## SUMMARY REPORT

**Application Ref:** 20230366

**Site Address:** Clifton Slipways, West Street, Gravesend, Kent.

Application for variation of condition 2 and 7 attached to planning permission reference no. 20191122 for the erection of two buildings to provide residential units (Use Class C3) with associated vehicle parking, cycle storage, highway works, and landscaping. Building 1 comprises the erection of a 23 storey tower on the north side of West Street to provide residential dwellings with B1a floor space at ground floor level; and Building 2 from four storeys to 12 storeys on the south side of West Street which will provide residential dwellings. The proposal includes the restoration and adaptation of the existing pier structure to provide public and private amenity space to include the erection of Business units (Class B1a) and a cafe (Class A1/A3); **to remove the basement at lower ground, relocation of bin store and plant, reduction of 23 car parking spaces and replacement of car parking at level 0 with 9 additional units (loss of 55 car parking spaces) within the Stuart Road Block.**

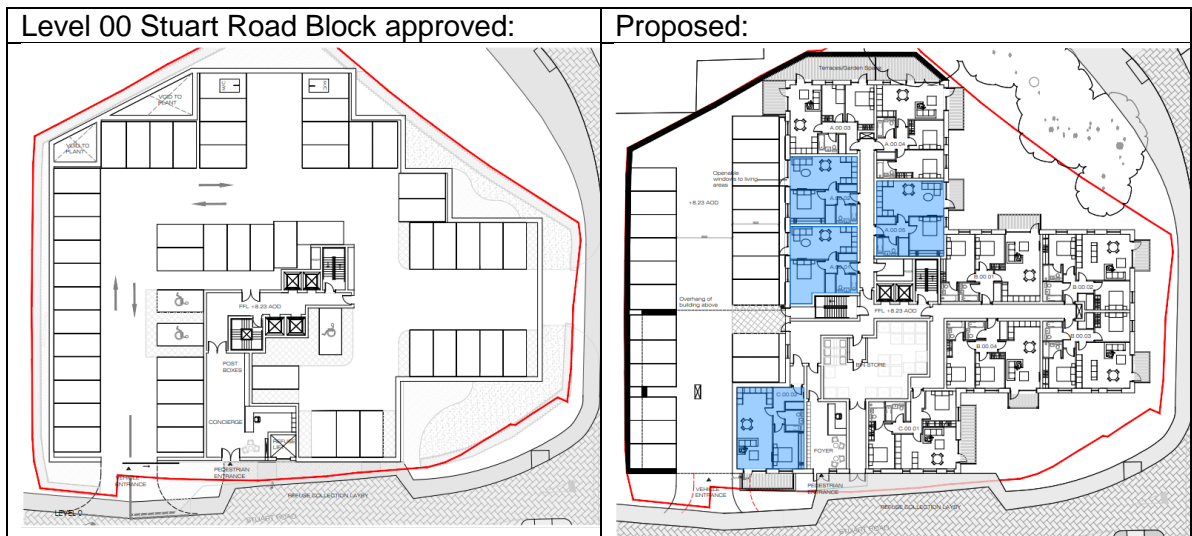
6.10. The proposal is to make both internal and external changes to the Stuart Road block. Internally level 00 of Stuart Road block is to have 34 car parking spaces removed and 9 additional units to provided. This is shown below:
